### Massachusetts Institute of Technology C.S. Draper Laboratory Cambridge, Massachusetts

## LUMINARY Memo #148

To:	Distribution
From:	B. McCoy
Date:	11 May 1970
Subject:	Call It LUMINARY 1D

Revision 163 of Luminary was released on 5/5/70 for manufacture. It contained a total of 39 PCRs, 6 PCNs, 15 ACBs and 6 Anomalies. On the following pages is a detailed description of each implementation or a reference made where appropriate.

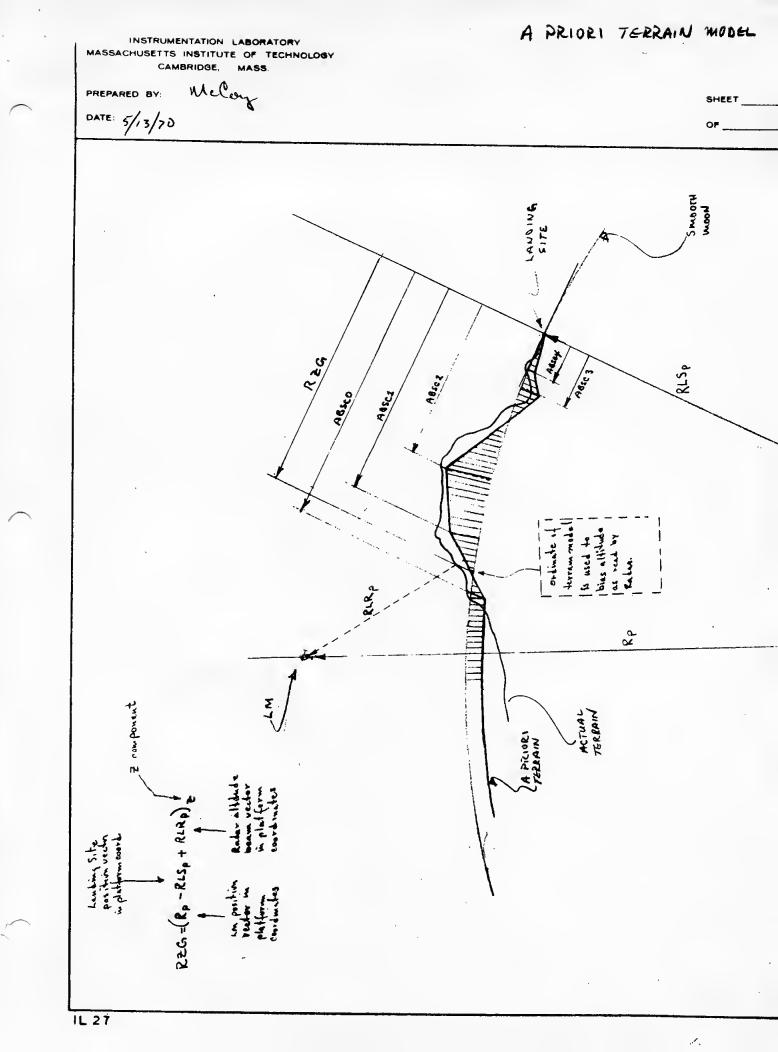
A new padload (LRWH1, E7, 1756) was created to allow for a two-segmented altitude weighting function. The present scheme is as shown below.

given by equation  $W_H$  = LRWH (1 - HCALC/LRHMAX). LRWH is set equal to LRWH1 in P64.  $W_H$  is altitude weighting function.

LRWH, LRWH1, and LRHMAX are erasable to set the slope. HCALC estimated altitude.

# A PRIORI TERRAIN MODEL

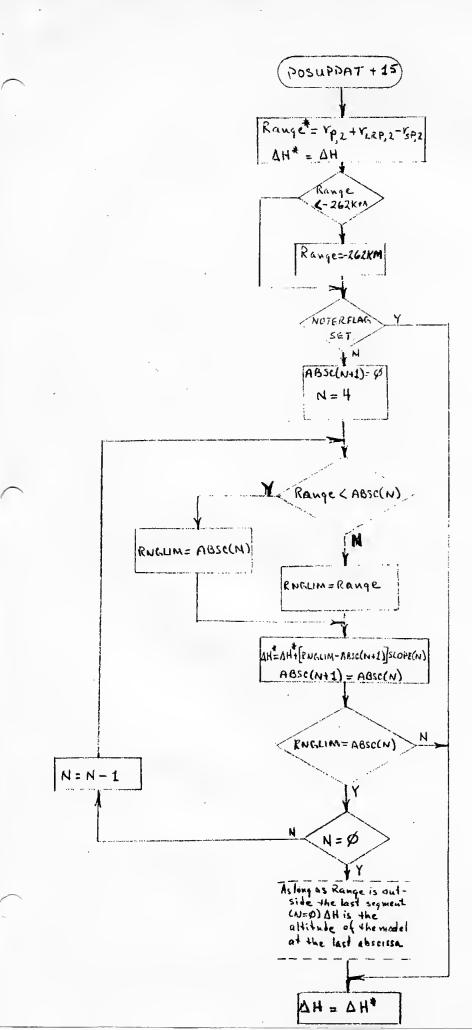
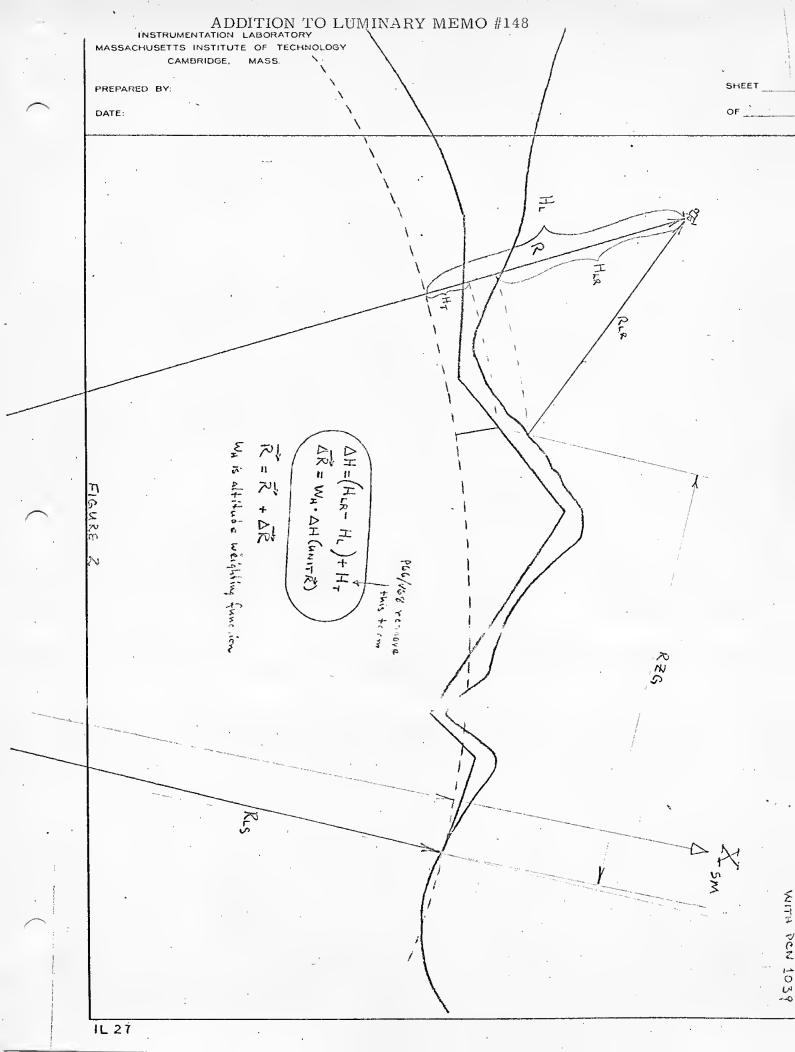
1027/1035 An a priori Terrain Model was implemented into Luminary to smooth the trajectory over rugged lunar terrain and to reduce the LPD errors and fuel consumption. It uses 5 segments, a slope and a range-to-landing site (abscissae), for each. The terrain not falling into the segmented region

(the model covers a region from some specified abscissae (range) to the landing site) will be modelled by a constant altitude, equal to the altitude at the last abscissae. The slopes and abscissae are specified in E memory by SLOPEO, 1, 2, 3, 4 and ABSCO, 1, 2, 3, 4. SLOPE and ABSCC correspond to the segment nearest the landing site (loc E5, 1527 and E5, 1522 respectively, scaled B-6 and B-18 respectively). For more details see Luminary Memo # by Allan Klumpp, Don Eyles, and Bruce McCoy.

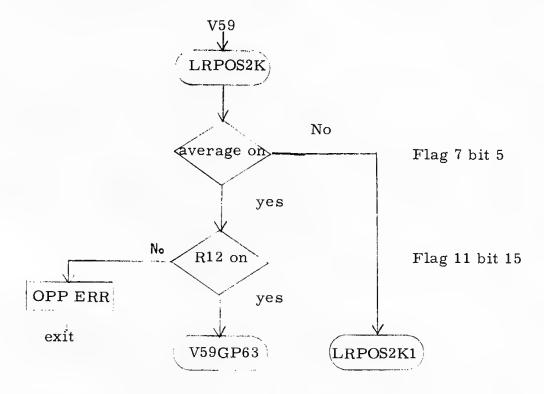
L-1C-03 A coding error in V59 leadin caused the DAP estimated attitude errors to be placed on the FDAI needles as well as moving the LR antenna to position #2. It was rewritten as shown below:

Now, V59 can be used in P64 if desirable.
